COMPREHENSIVE PLANNING COMMITTEE MEETING
Tuesday, January 23th, 2024, 12:00 noon
AGENDA

**Re: Krocks Road Mixed Use - Land Use of Regional Significance
Lower Macungie Township
Lehigh Township**

**RE: Zoning Map Amendment – 33 West Walnut Street
City of Bethlehem
Northampton County**

The seven lanes that pedestrians must cross is indicated by the red arrow

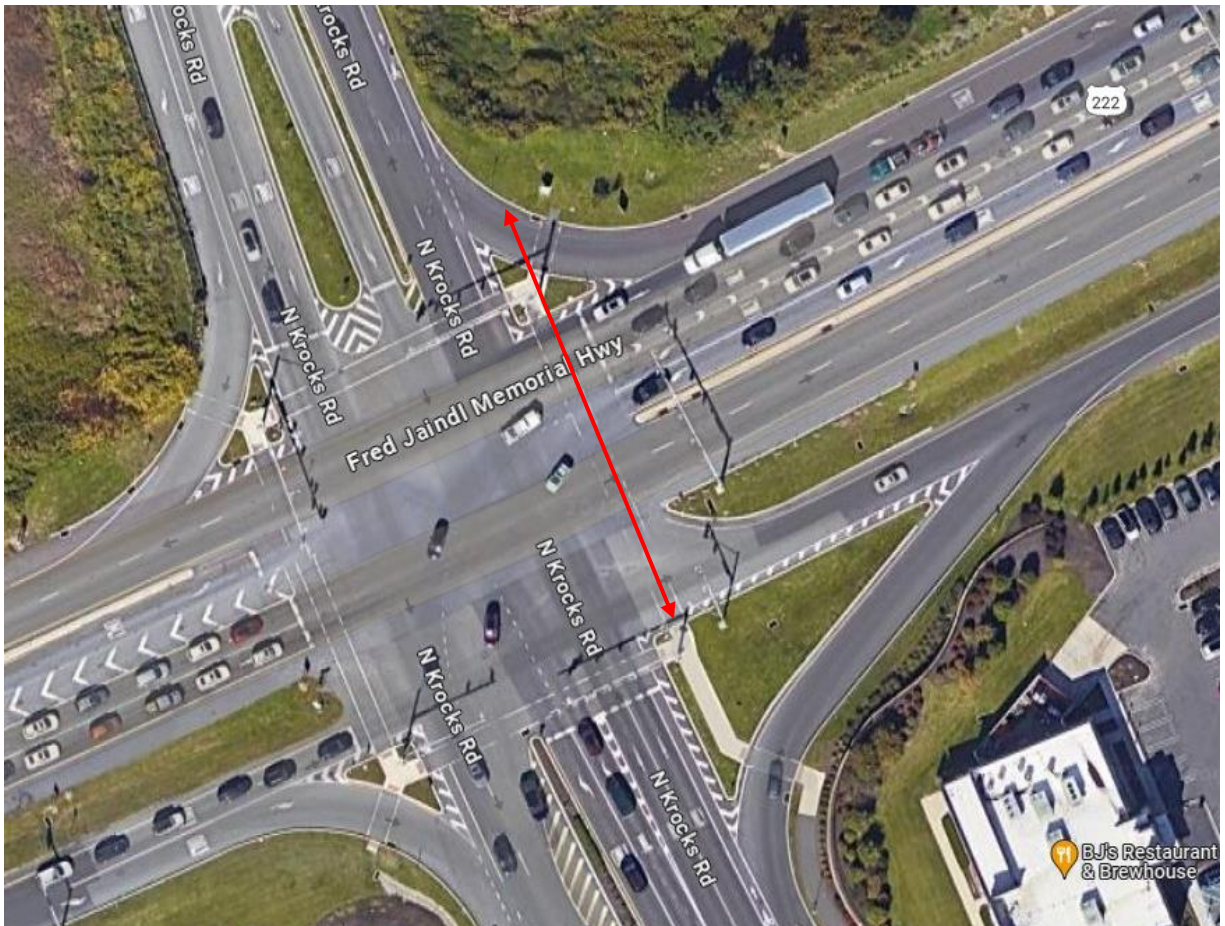
The LVPC strongly recommends that improvements be made at the intersection of 222 and Krocks Road. The apartment buildings and hotel will increase pedestrian traffic, adding to the numbers that already use public transportation and must cross this intersection, especially to reach Hamilton Crossings retail center on the south side of Route 222 from the development. Pedestrians must cross seven lanes of traffic.

The LVPC 'promotes context-specific design solutions' (of Policy 5.4) for 'safe and secure community design' (Policy 5.1) and strongly recommends that the pedestrian timed crossing light be time extended to allow sufficient time people of all ages and abilities to safely cross traffic including those people who use a mobility device or tool such as a wheelchair, walker, scooter, who are pushing a stroller or using a white cane. Inequalities in walking/rolling speeds based on age and ability impact people's capability to use crosswalks within the allotted time.

Additionally, the LVPC suggests additional safety measures such as refreshing the pedestrian cross walk marking and adding a pedestrian refuge island, which according to the Federal Highway Administration, protect pedestrians from traffic and can reduce crashes with pedestrians by 32%. These additions would increase pedestrian safety supporting Policy 5.1 to 'reduce bicycle and pedestrian fatalities toward zero'.

The LVPC strongly recommends that the municipality work with the Pennsylvania Department of Transportation (PennDOT), and the developer to study possibilities at this intersection to maximize safety and mitigate congestion to 'provide a safe, well-maintained transportation network to move people and goods efficiently, while capitalizing on existing infrastructure (Policy 2.2). The LVPC also recommends
